NEW MEXICO OIL CONSERVATION DIVISION

Re: Application of Black Hills Gas Resources, Inc. for administrative approval of an unorthodox well location for its Many Canyons 29-04-28 Well No. 121 (API No. 30-039-30231) in the Pictured Cliffs formation, Gobernador Pictured Cliffs Pool (Pool Code 77440) at a surface location 1895 feet from the North line and 670 feet from the West line and a bottomhole location 700 feet from the South and East lines of Section 28, Township 29 North, Range 4 West, N.M.P.M., Rio Arriba County, New Mexico.

#121 surface location 10' offset - Upper PC North Half Section 28

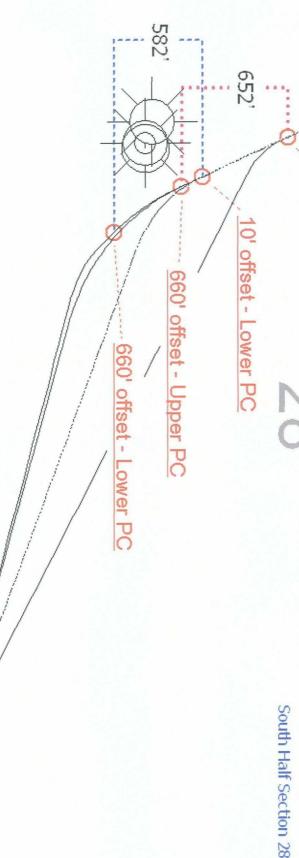
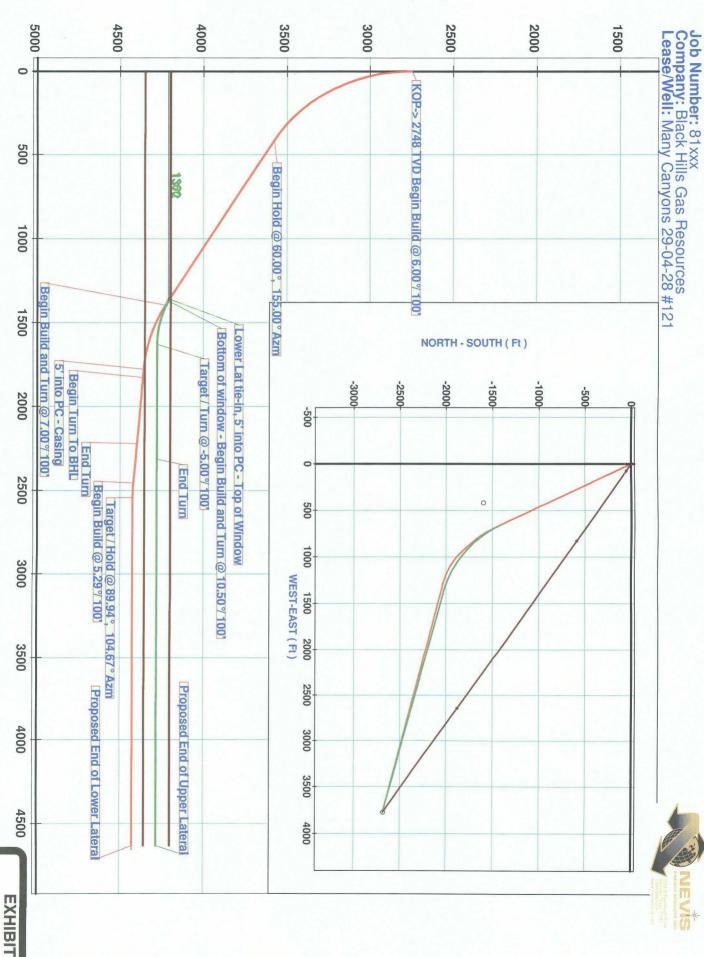
However, there is no information in your application from which I can figure even approximate footages for the point of penetration of the PC, and I need than information to write an order.

Please ask Black Hills' engineers to provide an approximation of footages for the point of penetration. I will draft an order and have it ready for issuance as soon as I receive that information.

The penetration point for the Upper Pictured Cliffs in the upper lateral is sec 28, 2567' FSL 1057' FWL. The penetration point for the Lower Pictured Cliffs in the lower lateral is sec 28, 2095' FSL 1277' FWL.
